SALEM NUCLEAR GENERATING STATION, UNIT NO. 1

AMENDMENT TO FACILITY OPERATING LICENSE

Amendment No. 10  
License No. DPR-70

ATTACHMENT TO LICENSE AMENDMENT NO. 10

FIGURE 6.2-1. OFFSITE ORGANIZATION FOR FACILITY MANAGEMENT AND TECHNICAL SUPPORT

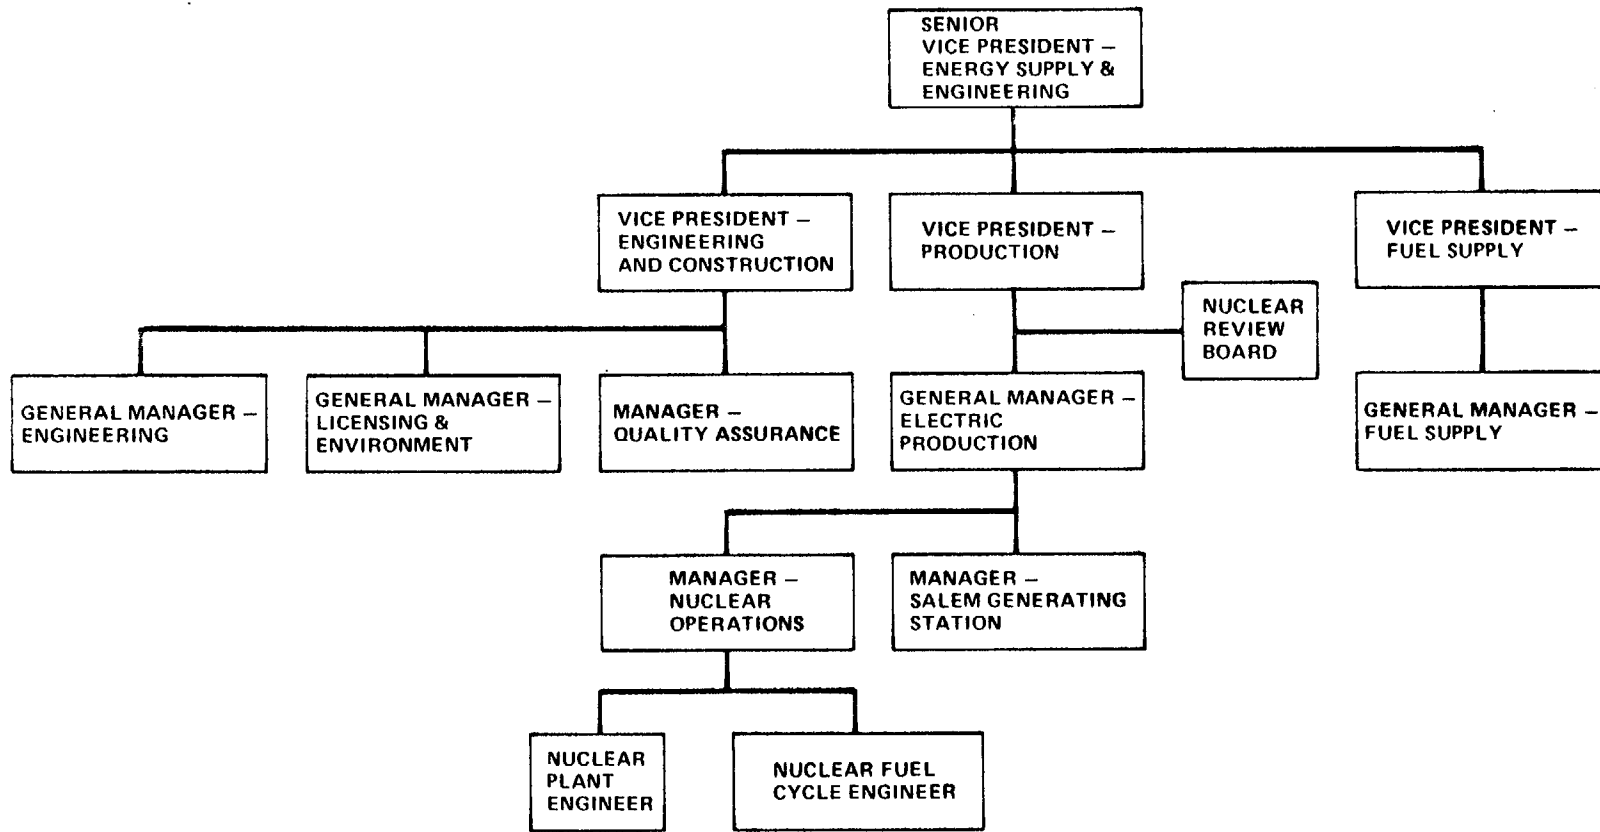
We have evaluated your request to update Organizational Charts (both Site and Corporate) and to make title changes for key personnel. Since these changes are administrative in nature and do not involve revision to personnel qualifications or organizational functions, we find them acceptable. It is further noted that the addition of two staff positions reporting to the Manager - Salem Generation Station does not reduce, but rather enhances the expertise of his staff.

6.2.1 The offsite organization for facility management and technical support shall be as shown on Figure 6.2-1.
